# 05

## Comments and Responses – Railway Corridor

Figure: 5-1

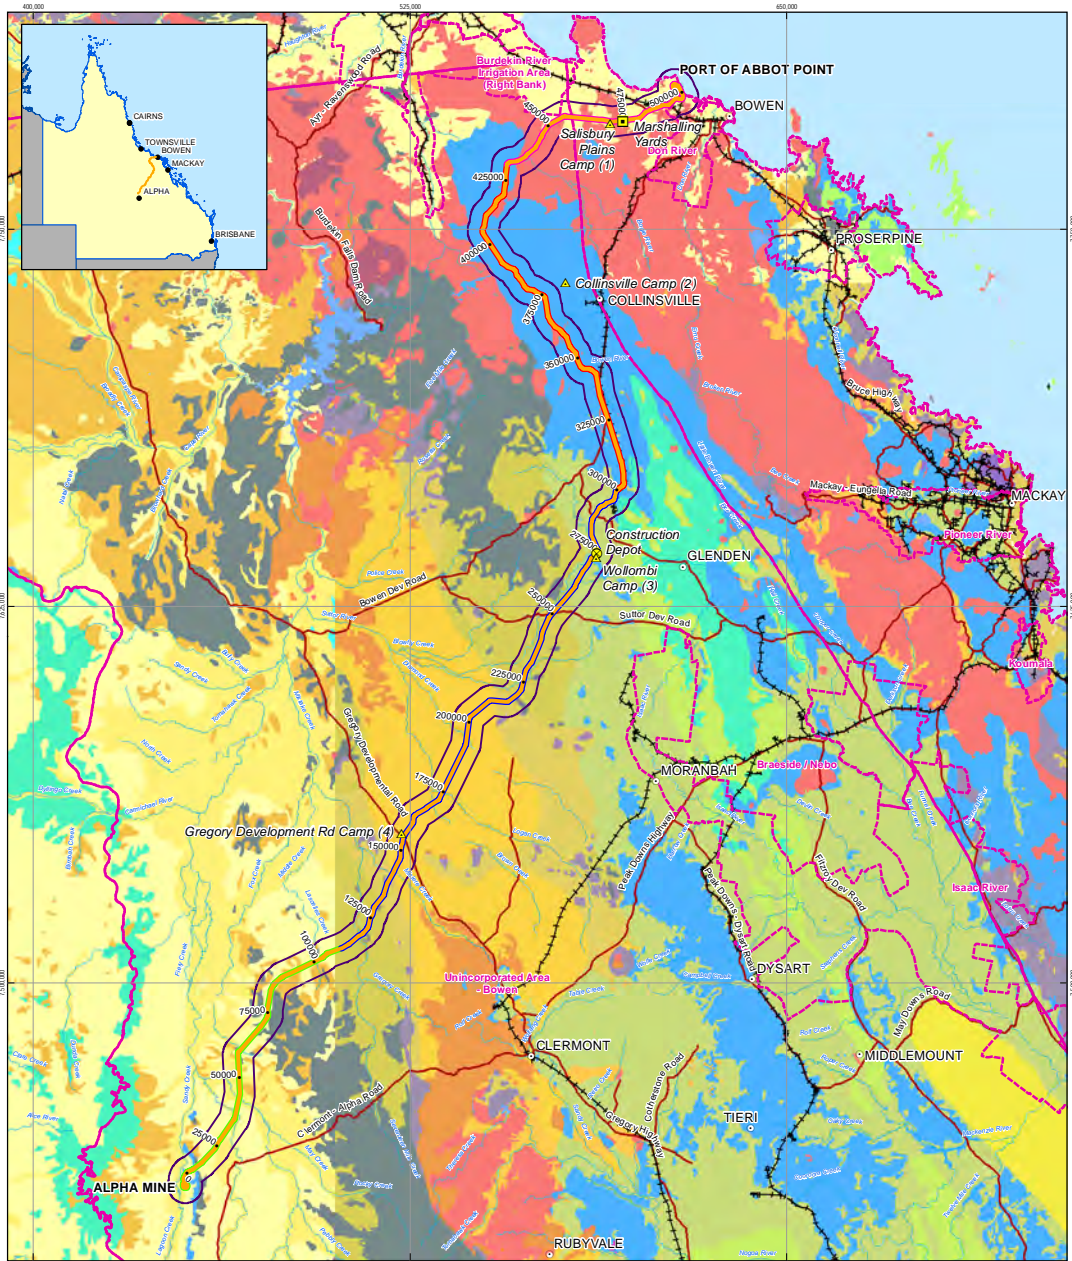
#### **Comment –RC19**

*The history of flooding data used is very broad and not detailed enough for this EIS. The History of flooding has been seriously under-estimated. Water Resource records from the Eaglefield gauging station show that flooding from the Suttor has occurred downstream in our property seven times since 1974 and Eaglefield creek has flooded a lot more in the same period [personal records].*

Tertiary to Quaternary aged sediments directly underlie the majority of the alignment from the Alpha Mine to chainage 310 km and 450 km to 510 km (refer to Figure 5-1 below), predominantly within

Sections 1, 2 and 4. Most of these sediments have been deposited by adjacent rivers, creeks and associated floodplains and consist of various compositions of sand, silt, gravel and clay.

Figure: 5-2  
Sheet 1 of 14

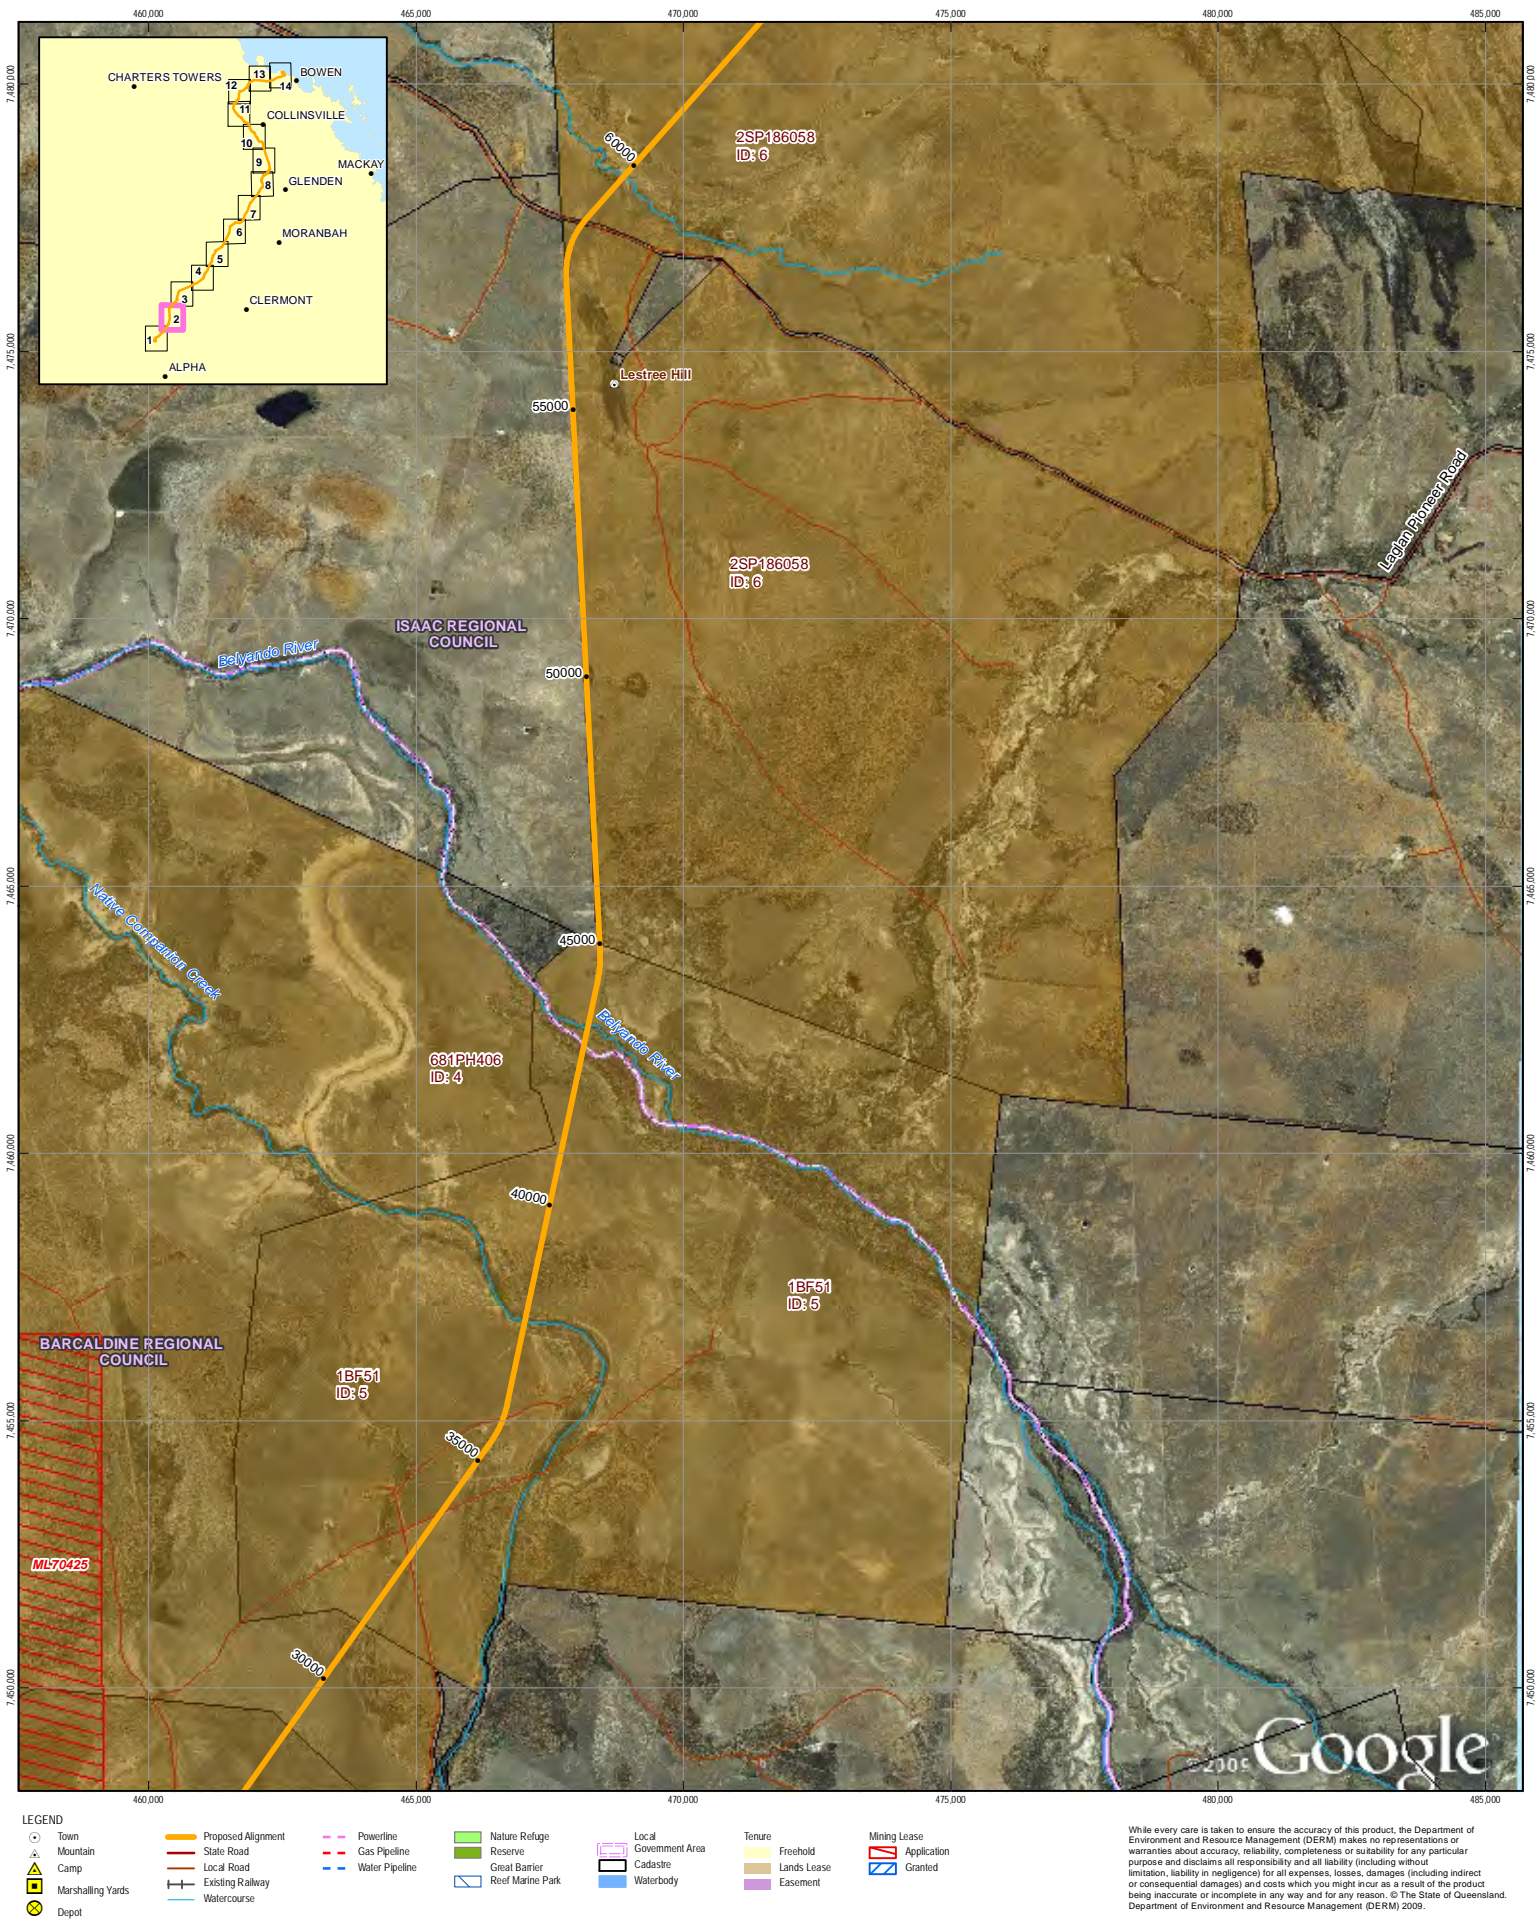
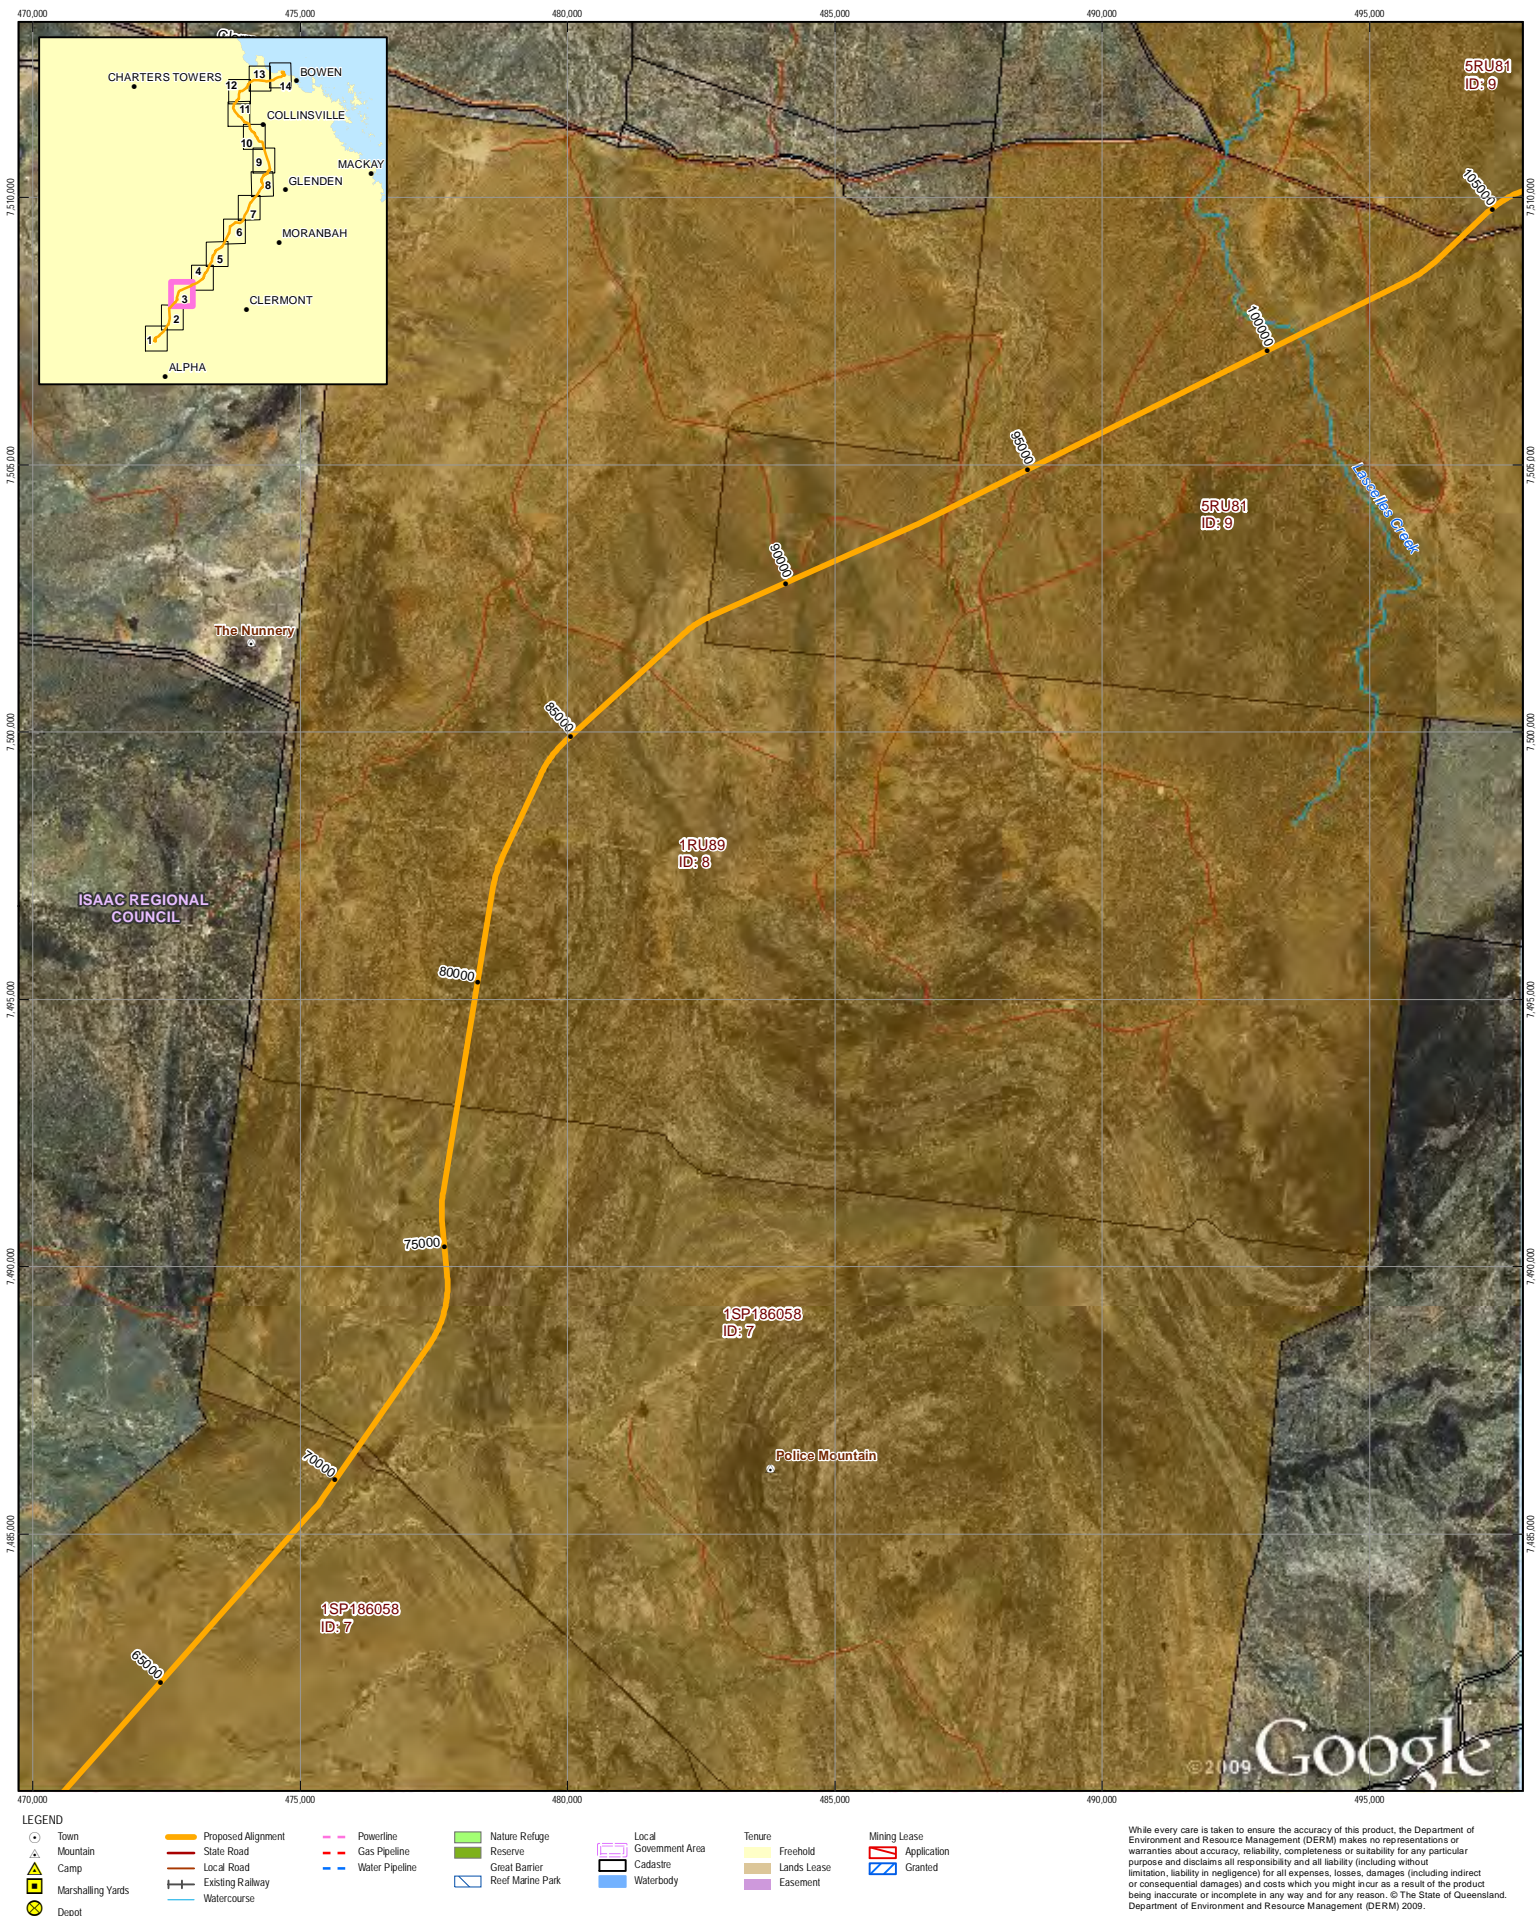
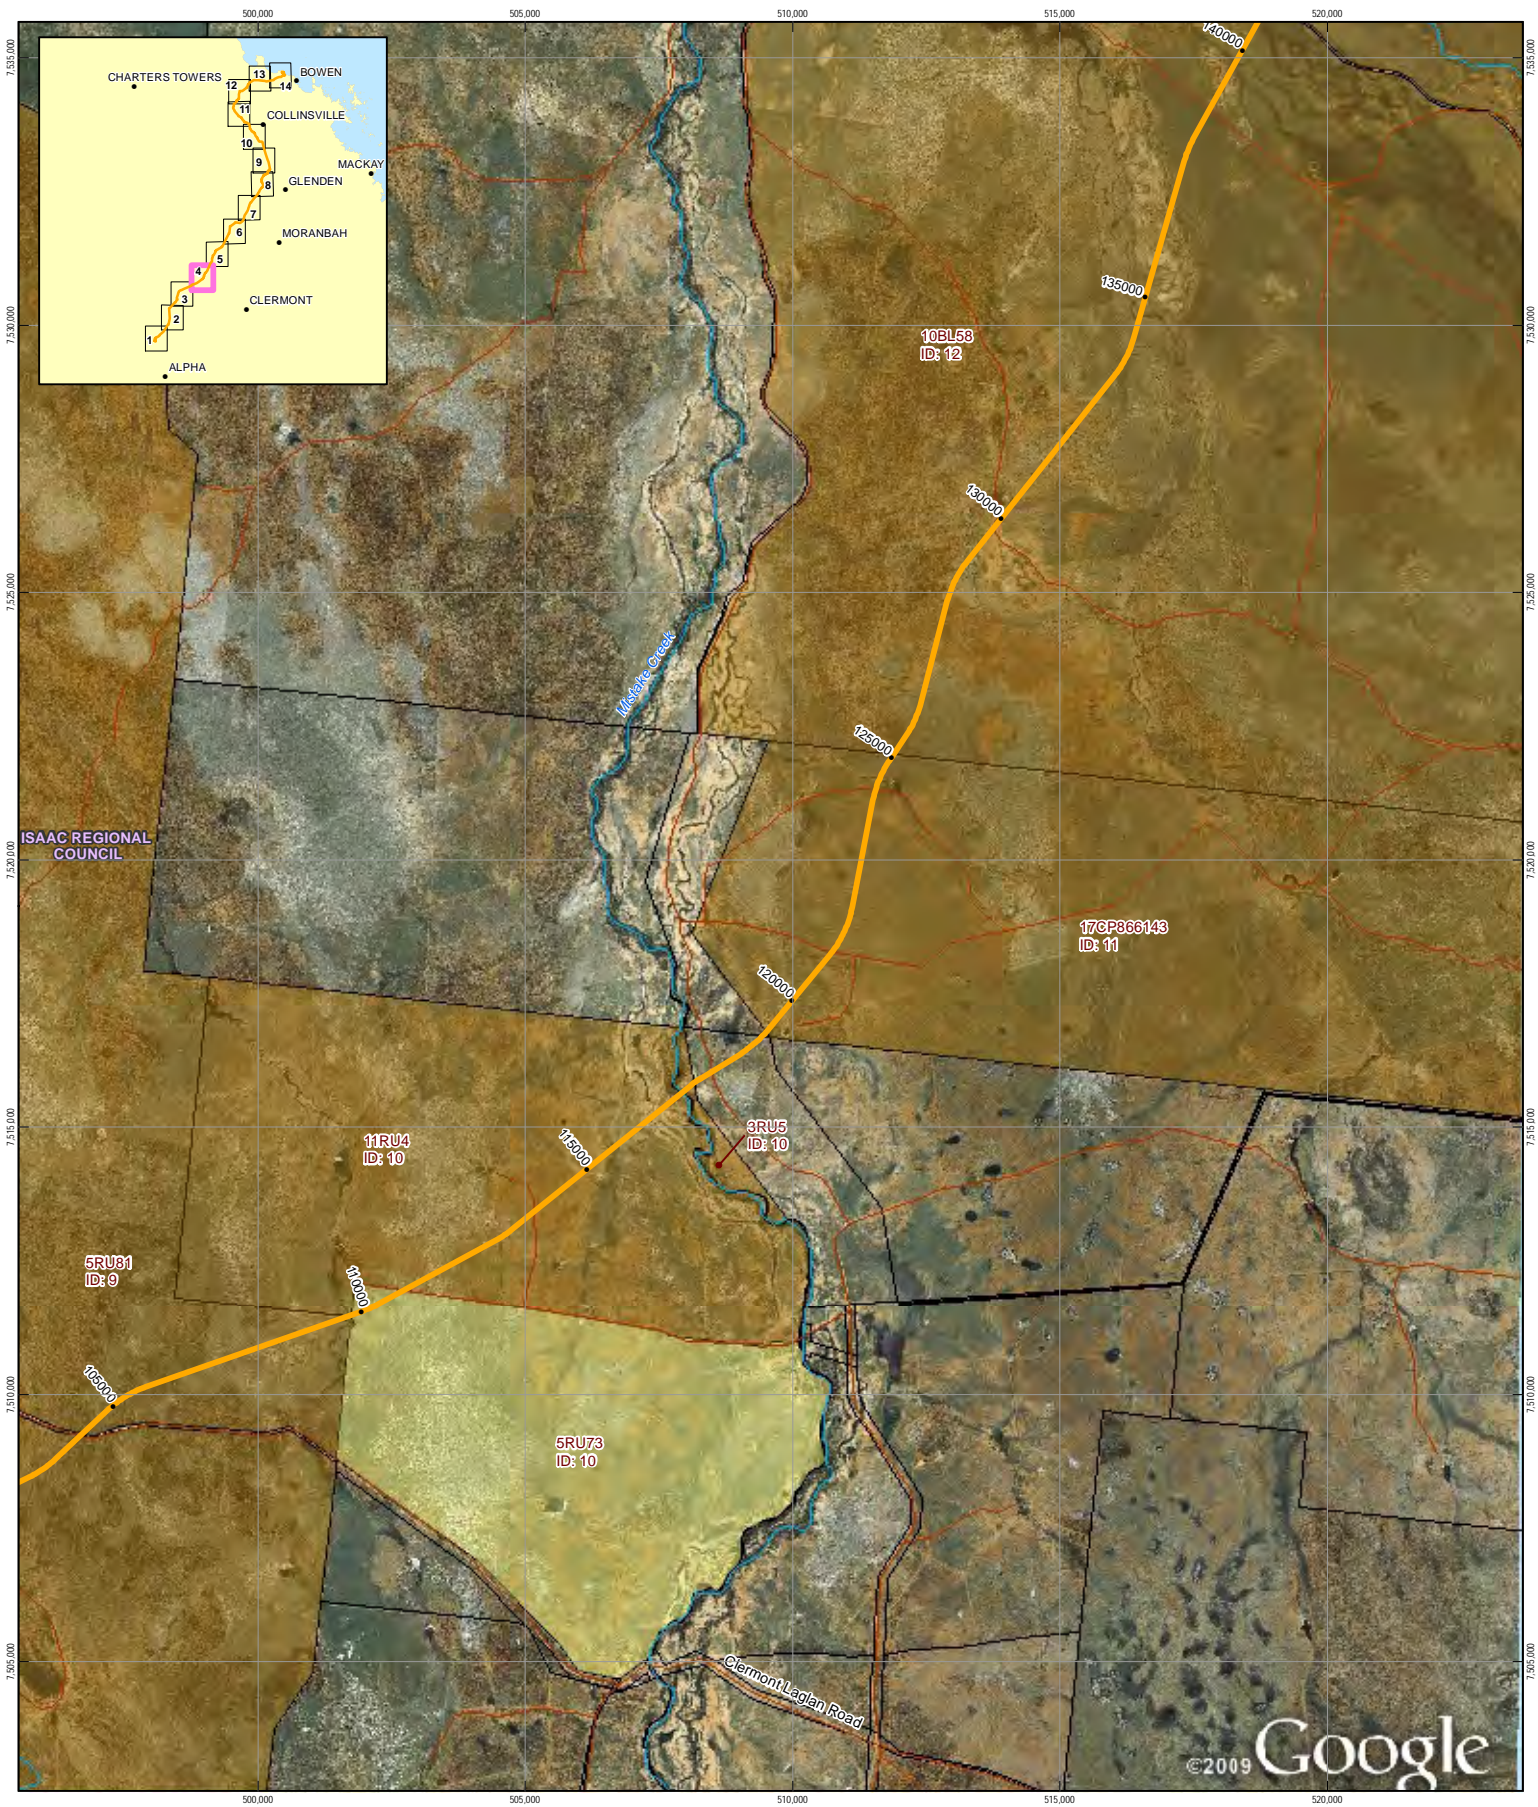
**5.23.5 Land use and Tenure****Comment – RC402**

*The proponent must describe all mining activities and mining tenures along the proposed railway corridor in this section of the EIS (existing environment).*

All mining activities are demonstrated in updated in Figure 5-2 below.
